RHODE ISLAND CONTRACT NO.2017-CH-039

**Blackstone River Bikeway (Segment 8C)**

NOTICE TO PROSPECTIVE BIDDERS

ADDENDUM NO. 1 Prospective bidders and all concerned are hereby notified of the following changes in the Plans, Specifications, Proposal and Distribution of Quantities for this contract. These changes shall be incorporated in the Plans, Specifications, Proposal and Distribution of Quantities, and shall become an integral part of the Contract Documents.

GENERAL PLAN &  
PROFILE NO. 1

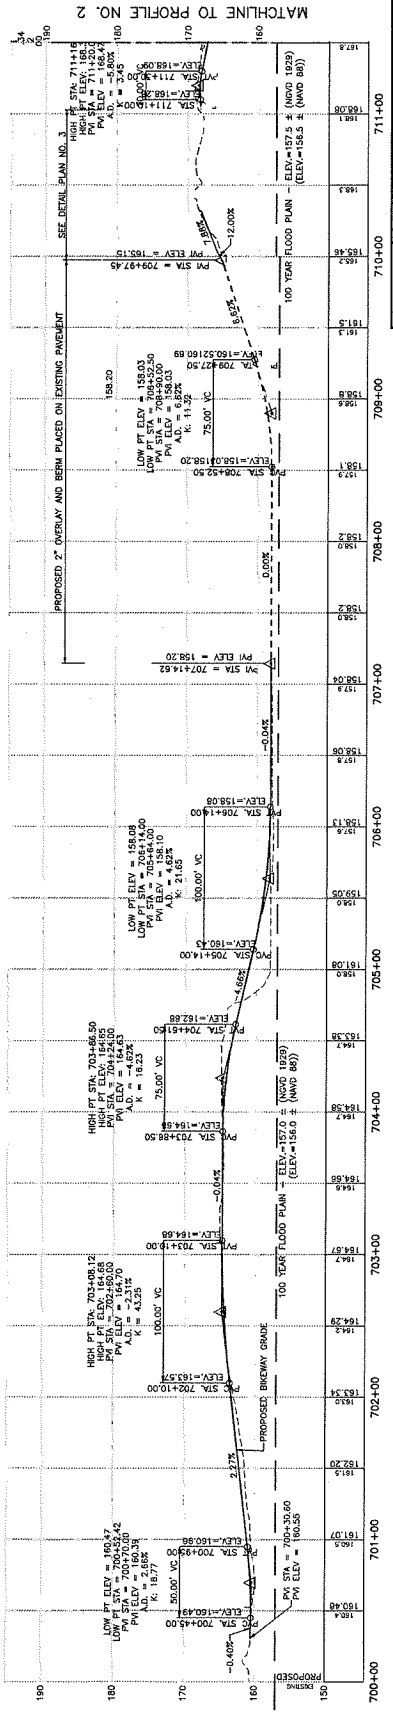
Delete Plan Sheet 7 in its entirety and replace it with Plan Sheet 7(R-1) attached to this Addendum No. 1. A location for the relocated utility pole has been added.

RHODE ISLAND  
 DEPARTMENT OF TRANSPORTATION  
 BLACKSTONE RIVER BIKEWAY  
 SEGMENT 8C  
 WOONSOCKET TO N. SMITHFIELD  
 LOCATION PLAN NO. 1  
 CHECKED BY: DATE: SCALE:

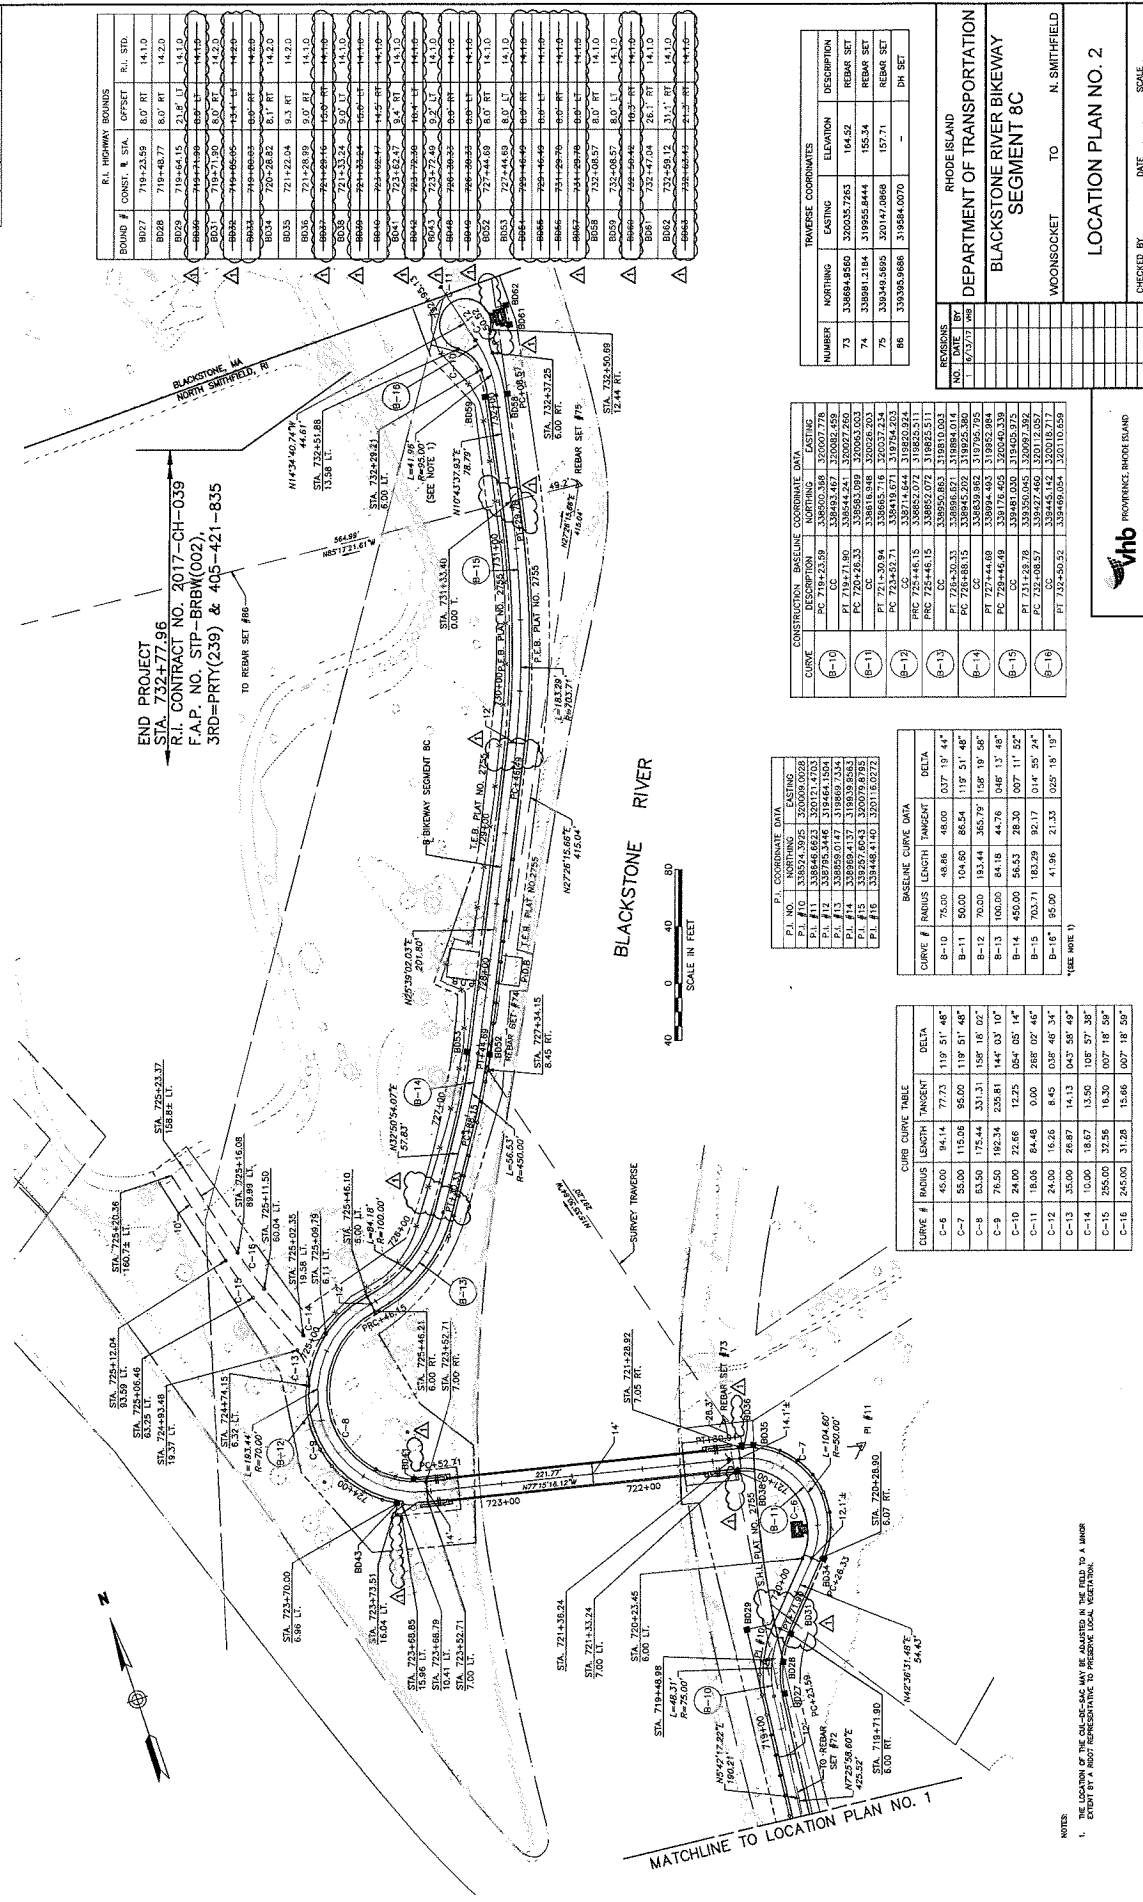
Delete Plan Sheet 10 in its entirety and replace it with Plan Sheet 10(R-1) attached to this Addendum No. 1. The highway bounds have been revised.

**SWING GATE AND FOUNDATION**  
SCALE: NTS

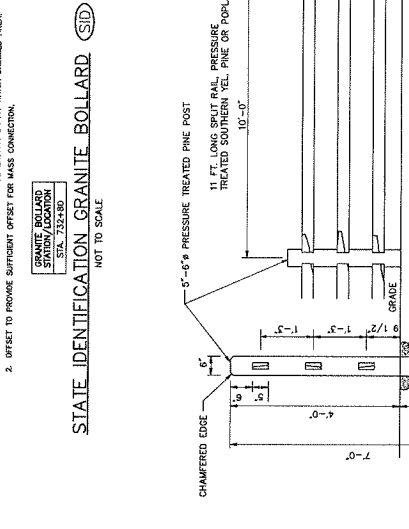
Delete Plan Sheet 15 in its entirety and replace it with Plan Sheet 15(R-1) attached to this Addendum No. 1. The swing gate and foundation detail has been modified.

**FOUNDATION AND PILE PLAN**

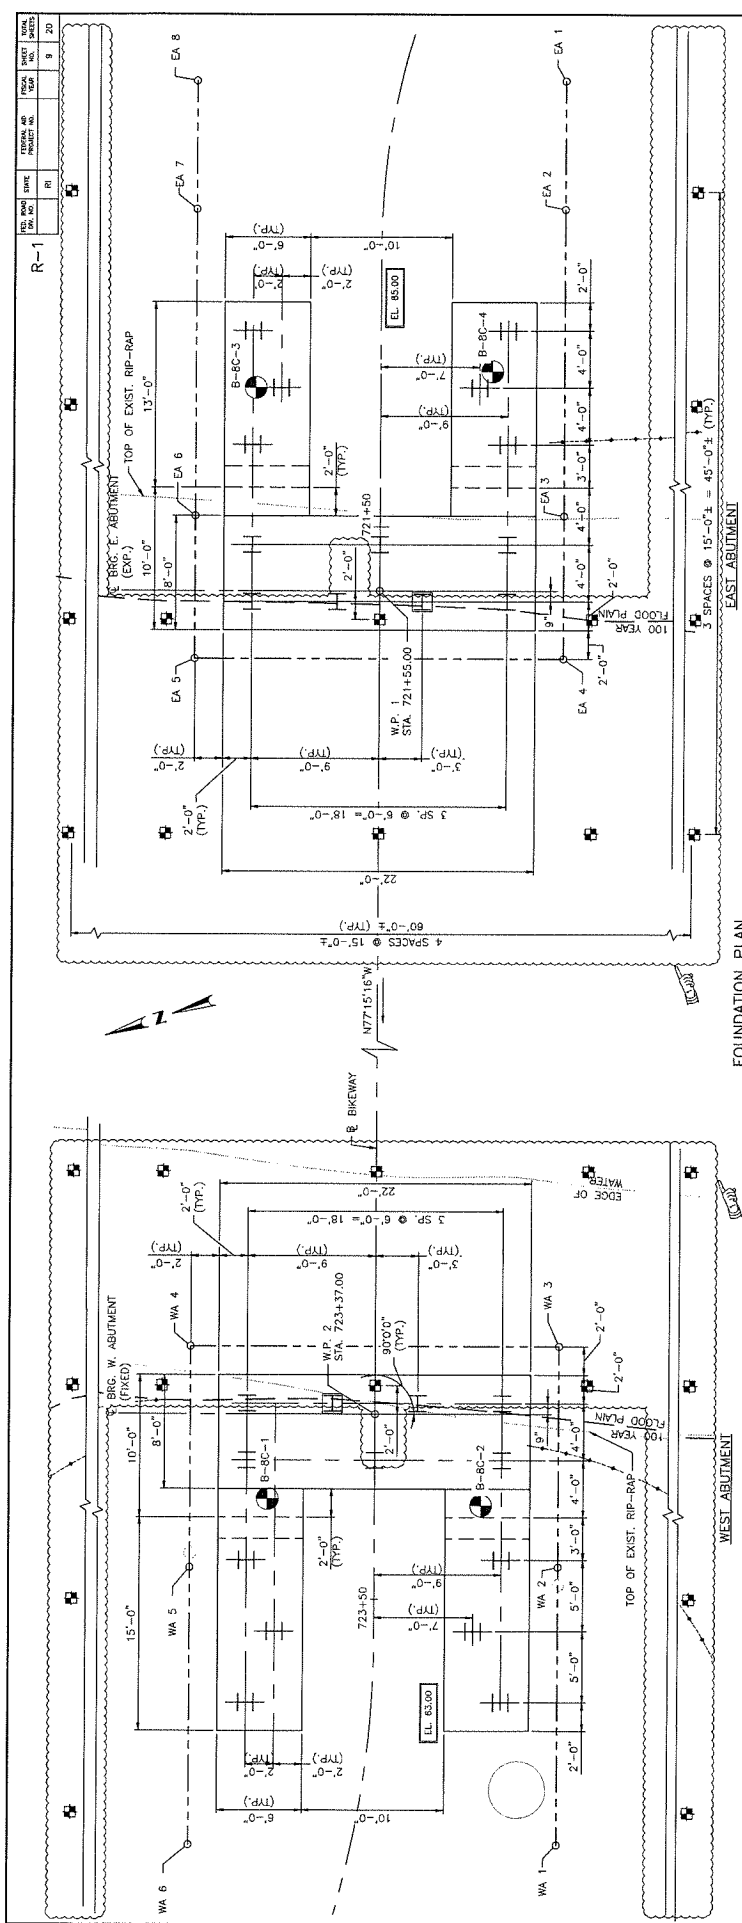
Delete Plan Sheet 9 in its entirety and replace it with Plan Sheet 9(R-1) attached to this Addendum No. 1. The abutment details have been updated.
